PROJECT Tylér Acres 6th

REFERENCE Drainage Plan

Re: S/D 82-57 - Preliminary plat of Tyler Acres Sixth Addition

Re: S/D 82-57 - Final plat of Tyler Acres Sixth Addition

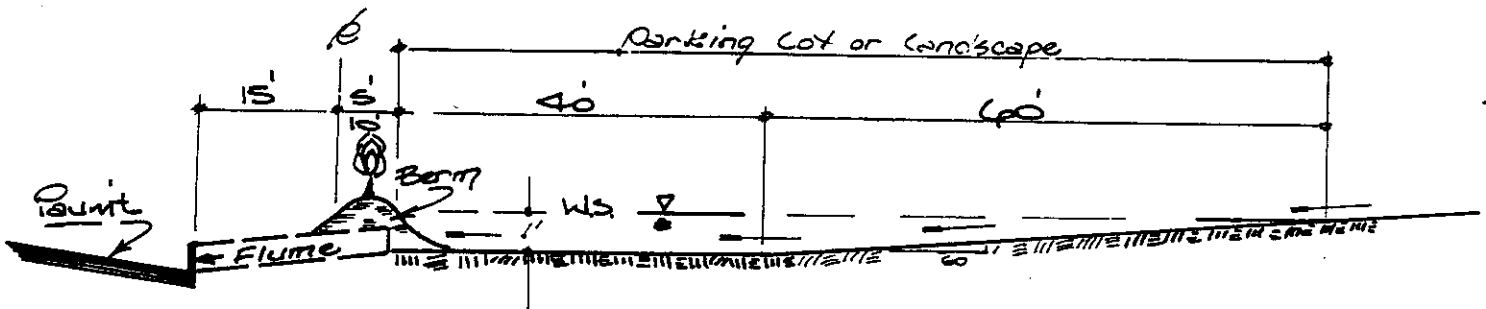
The developed runoff factor for the Area F will be 0.60. Time of concentration was checked and determined to be less than 15 min., so the intensity is to be used at 15 min.

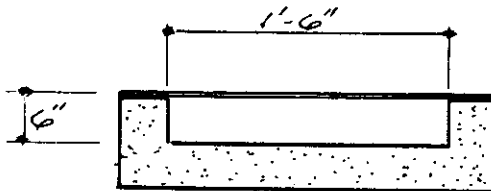
Available end section area in this layout is approximately 70 S.F. The total length of storage area would be 45,360 C.F./70 S.F. = 648 L.F.

The approximate area in the plat to be utilized as storage area would be dimensioned roughly as a 100' X 650' rectangle or equivalent in which water will not exceed a 1 foot depth from the runoff generated by the major 100 year storm.
